WINDERMERE FILING NO. 2

EARLY GRADING & EROSION CONTROL PLANS

WINDERMERE FILING 2
GRADING & EROSION CONTROL
N. MARKSHEFFEL ROAD
EL PASO COUNTY, COLORADO

ISSUE	DATE
INITIAL ISSUE	4/1/22
RESUBMITTAL	6/07/24

**INITIAL
 EROSION CONTROL
 PLAN**

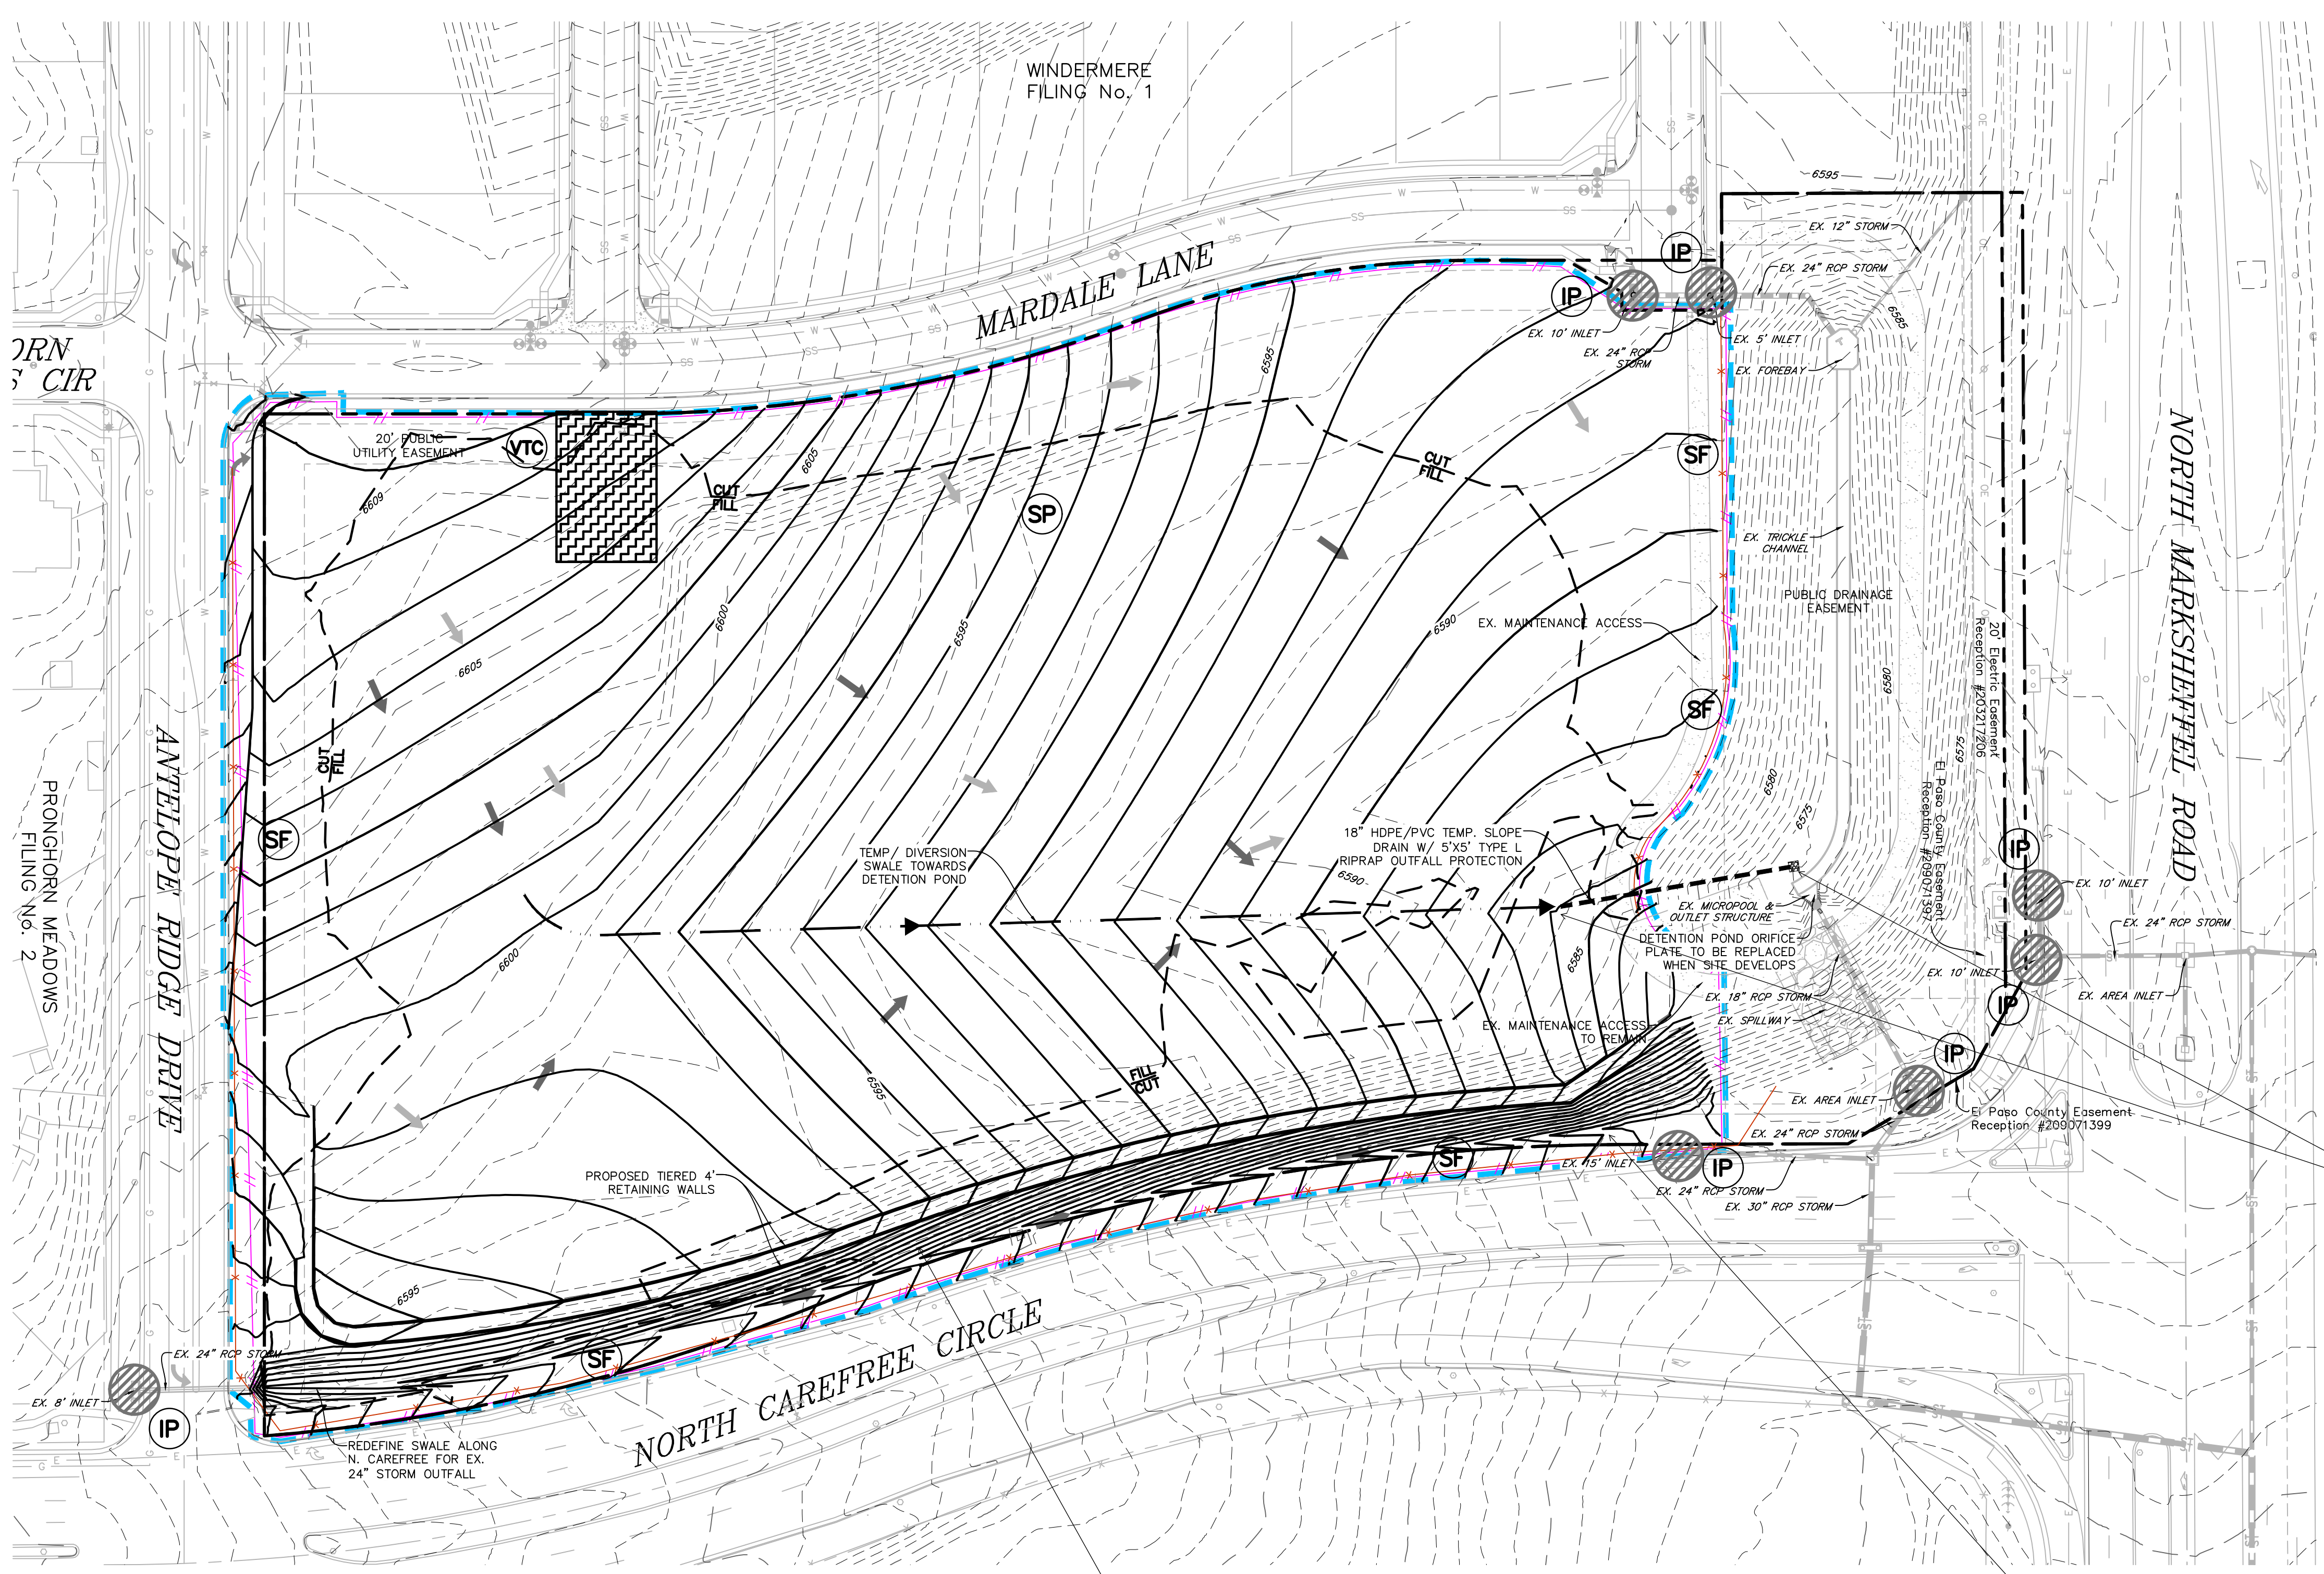
consider BMPs both upstream at at Outlet to treat 8ac of disturbance prior to discharging offsite

include checks in ditch to prevent erosion and sediment transport in areas with concentrated flows

TSB or sediment trap needed to treat flows that are bypassing pond

show location of CWA as indicated on the FAE
